SYDNEY EASTERN CITY PLANNING PANEL DEVELOPMENT APPLICATION ASSESSMENT REPORT

ITEM No.	0.0
FILE No.	DA598/2022/1
ADDRESS	17 Dover Road ROSE BAY (along with the road reserve)
SITE AREA	2,398m ²
ZONING	E1 Local Centre
PROPOSAL	Demolition of existing at-grade car park and encroaching structures and construction of: A mixed use building with frontage to Wilberforce Avenue incorporating a new multi-storey car park, ground floor retail premises and community centre and public amenities across multiple levels; Single storey ground floor retail building with frontage to Dover Road; and public domain and landscaping works.
TYPE OF CONSENT	Integrated development requiring approval under s90(2) of the <i>Water Management Act 2000</i>
COST OF WORKS	\$28,826,432.00
DATE LODGED	22/12/2022
APPLICANT	Mr J Koopman
OWNER	Woollahra Municipal Council
AUTHOR	Mr V Aleidzans
TEAM LEADER	Mr M Moratelli
SUBMISSIONS	Seventy Seven (77) (Inclusive of repeat submissions)
RECOMMENDATION	Deferred Commencement and Conditional Approval

Image 19: Section plan showing the extent of building height non-compliance

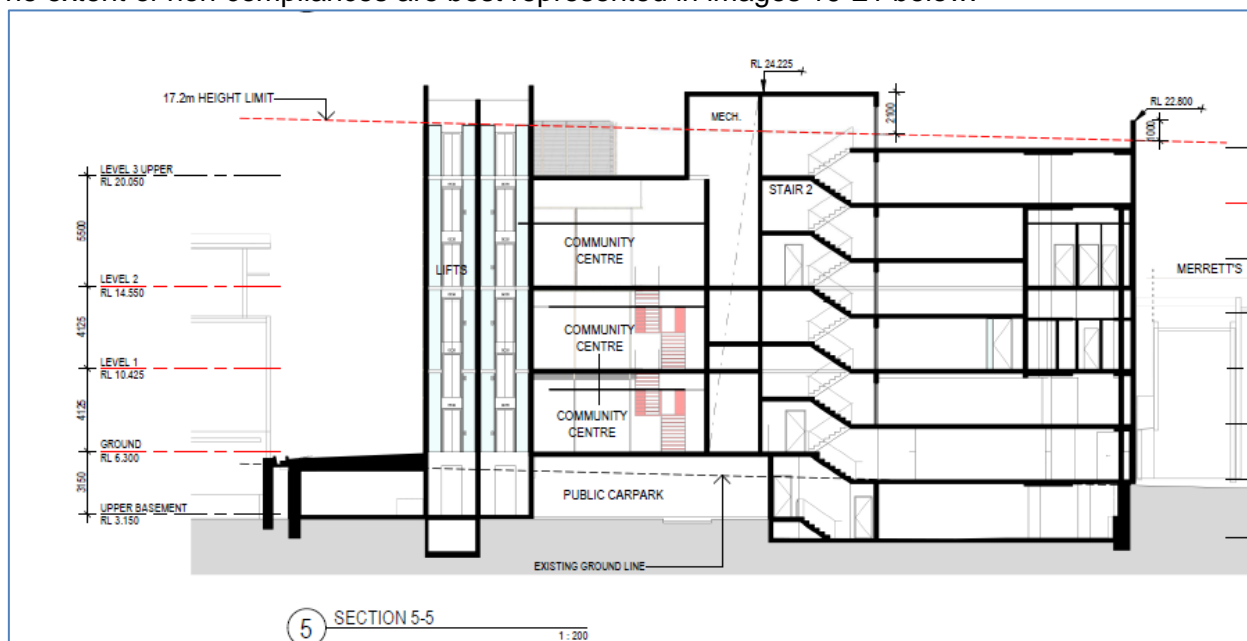
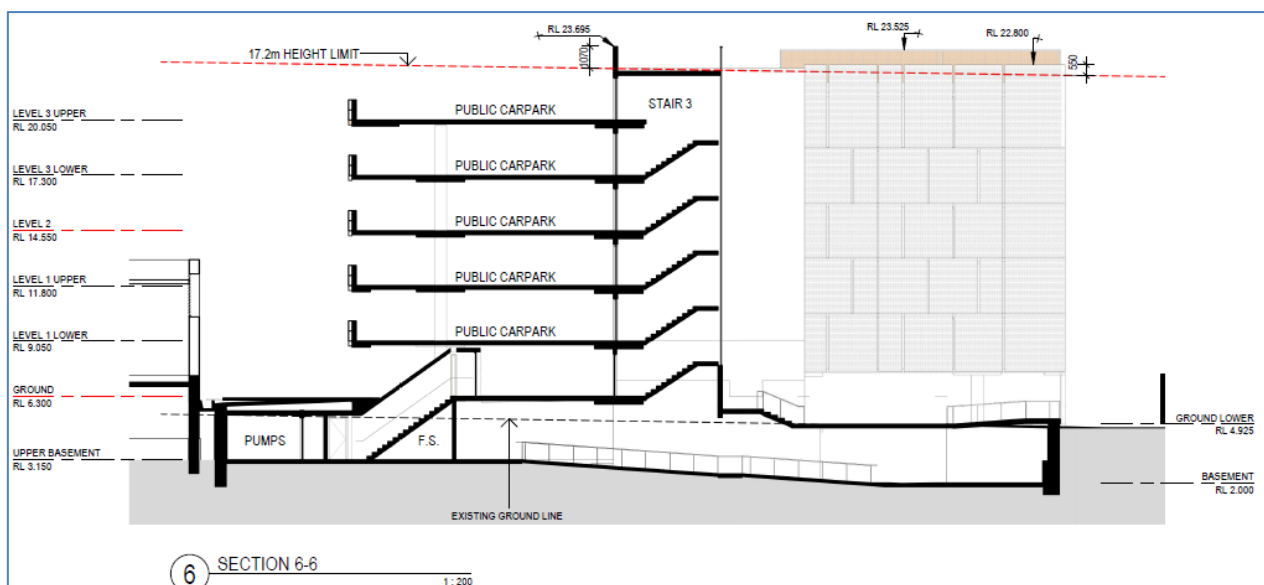
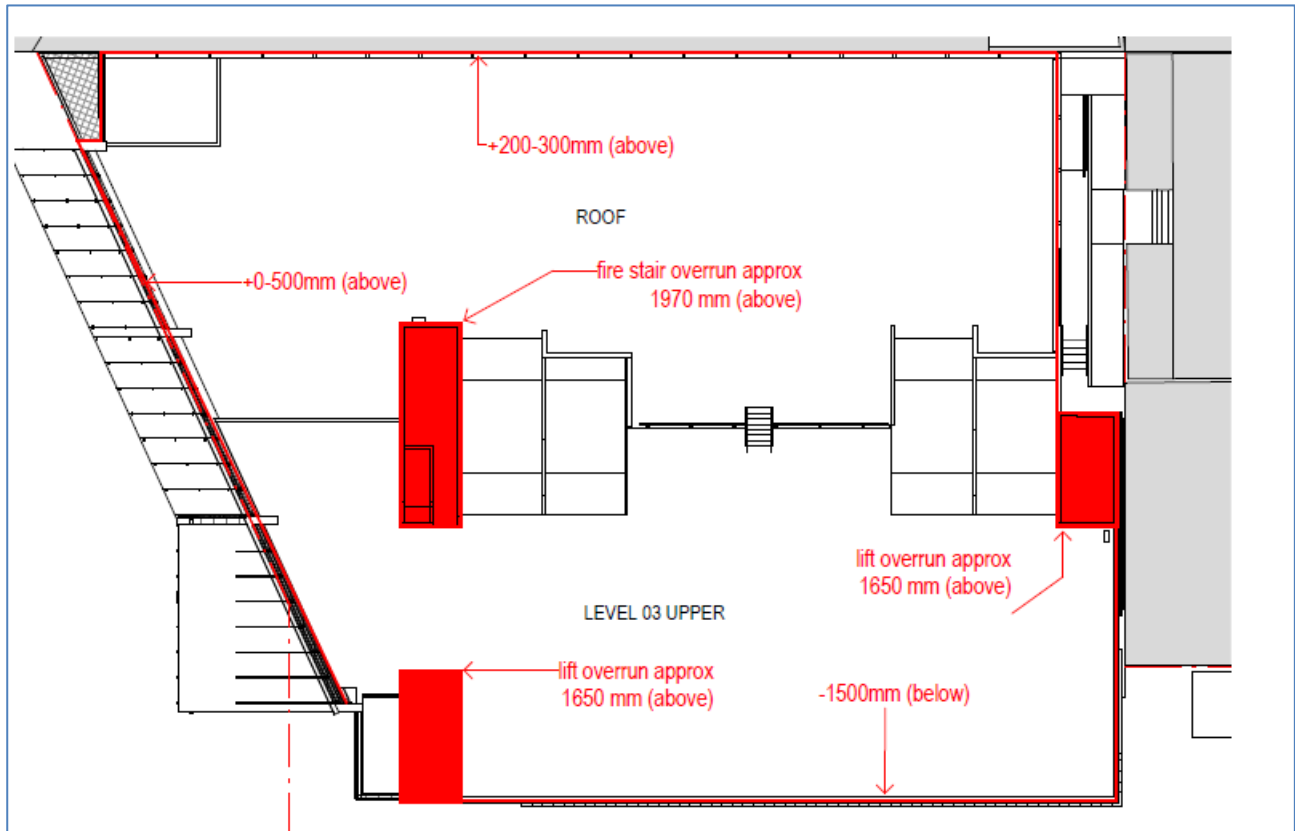
The proposal does not comply with Clause 4.3 of Woollahra LEP 2014 as detailed and assessed in Section 16.5 of this assessment report.

- 19.3m (RL24.225) fire stair;
- 18.9m (RL24.45) lift overrun;
- 18.7m (RL22.80) parapet; and
- 18.27m (RL23.695) fire stair at north-east boundary

The extent of non-compliances are best represented in images 19-21 below:

It is not considered that the extent of variation and its relatively contained nature would compromise the desired future character of the neighbourhood. Majority of the variation pertains to the proposed plant/service areas with majority of the principal building form (notwithstanding parapets) complying with the standard.

Notwithstanding the extent of non-compliances, the proposal is considered to provide a suitable transition to surrounding properties noting that majority (and the greatest extent of variations) relate to the service areas rather than the principal building form. Furthermore, the immediate adjoining properties provide for the same land zoning.

The subject non-compliances would not result in any significant view loss, loss of privacy, overshadowing or visual intrusion impacts to adjoining properties. The overall exceedances are not considered to result in a discernible increase to the overall bulk and scale of the proposal noting that the service areas including fire-stairs, plant and overruns would have a reduced visibility due to their positioning and are well integrated into the overall building design. There are no view corridors considered to be available from surrounding properties which the non-compliance would impact.

Image 23: Control drawing 4 within Part D6.5.7 of the Woollahra DCP 2015

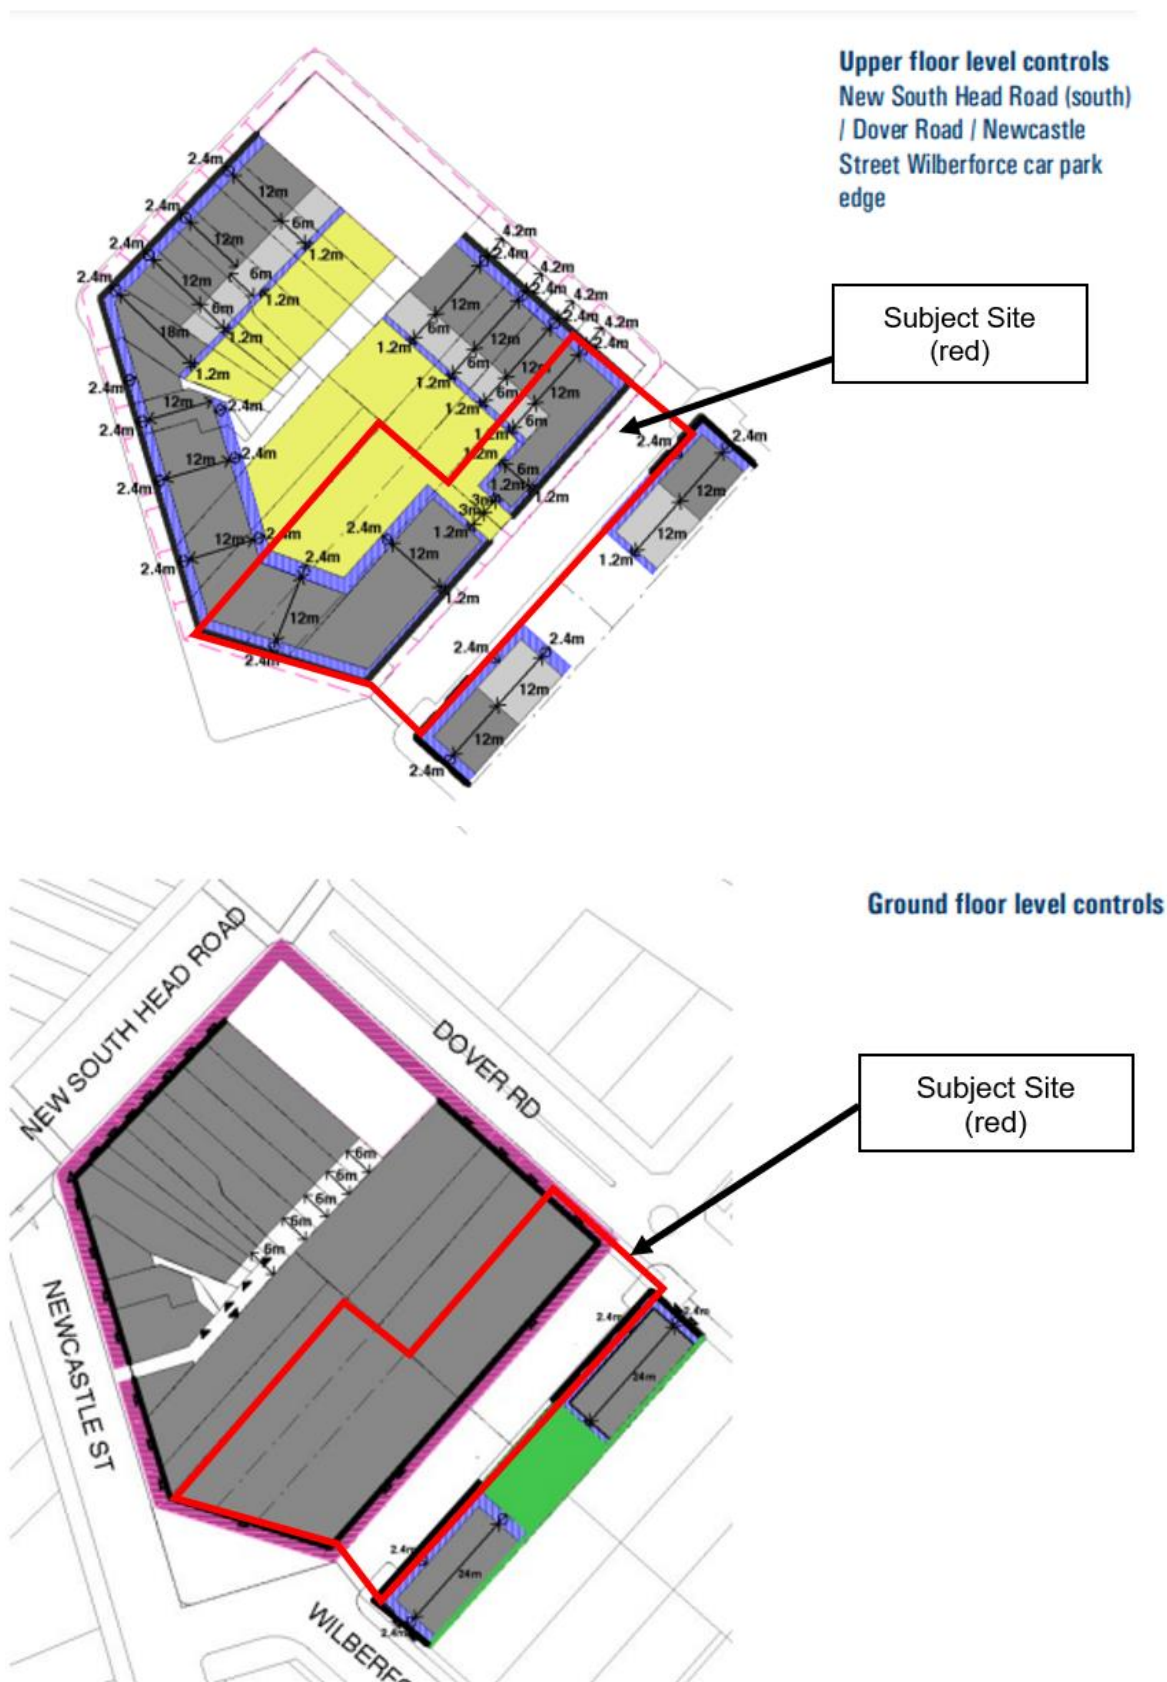
As detailed previously, and given the proposed development typology, not all requirements of control drawing 4 may be feasible nor would they properly facilitate the proposal.

Whilst this does not allow for exterior garden and courtyard spaces as required by objective O4 and envisaged by control drawing 4 (albeit two balconies are proposed addressing Wilberforce Avenue) these would not be in keeping with the proposed land uses and building typology, hence are not deemed necessary in this case.

C1 requires that building alignments should comply with those shown on the control drawings (see Sections 6.5.2-6.5.8). In this instance building to the site's frontages is permitted per control drawing 4 which is achieved by the proposal and is therefore compliant with C1.

The proposal is non-compliant with C1 as it has not been designed to the requirements of control drawing 4.

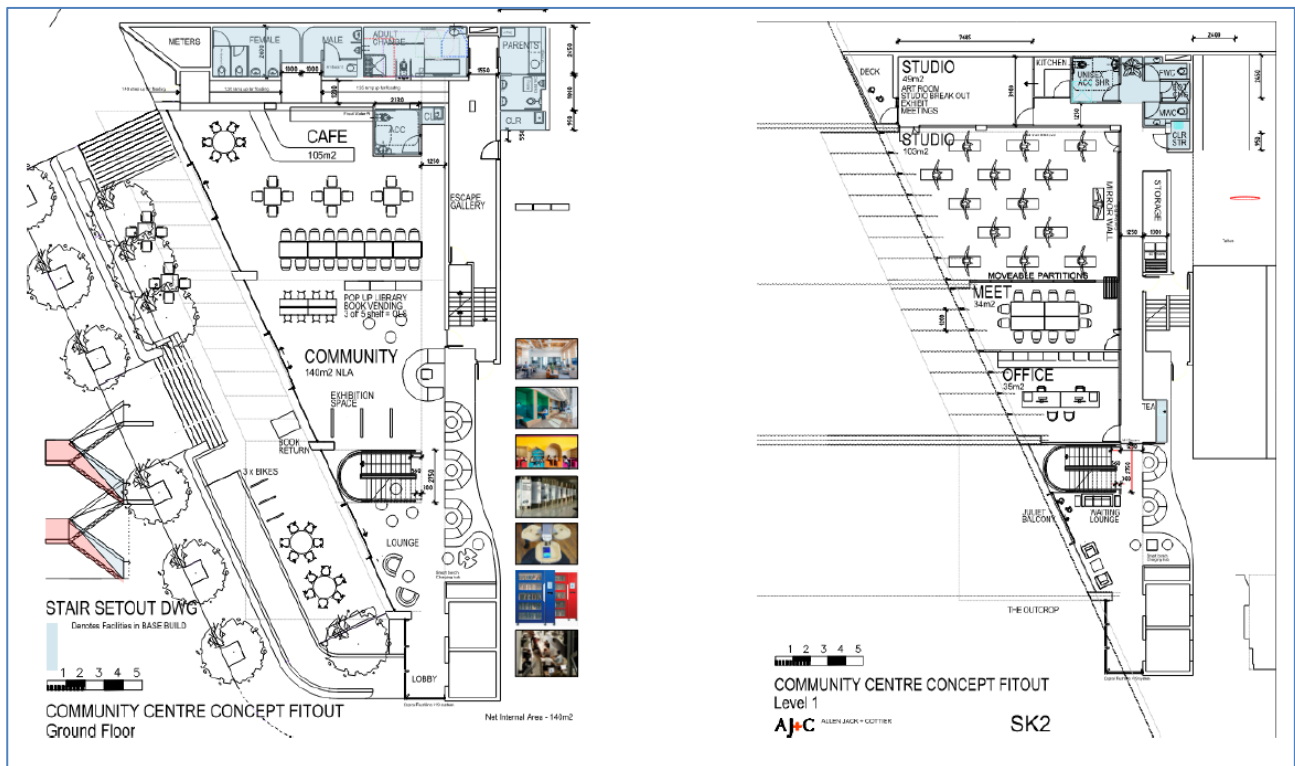
- *The design and location of stair 1 would also create possible sound transmission floor to floor and would impact community events occurring in different spaces.*

- *The access from the community centre to the amenities through the fire stairs is convoluted and may create confusion.*
- *The balcony on the south western corner is not connected to the large Community Centre space and appears relatively unusable. The proposed location for the balcony also increases congestion of the smaller 'lobby' space.*

It is important to reiterate that no detailed fit out of the community space is proposed as part of this application. The Applicant describes the community centre as a 'cold shell product' with the fit out being subject to a separate design process.

With regard to access from the car park to the community centre spaces, access can be provided at level 2 RL 14.55 to the Lobby space which is likely to contain meeting rooms. Service access is available on Level 1 at RL 10.425 to back of house areas. Level 1 is likely to contain activity spaces.
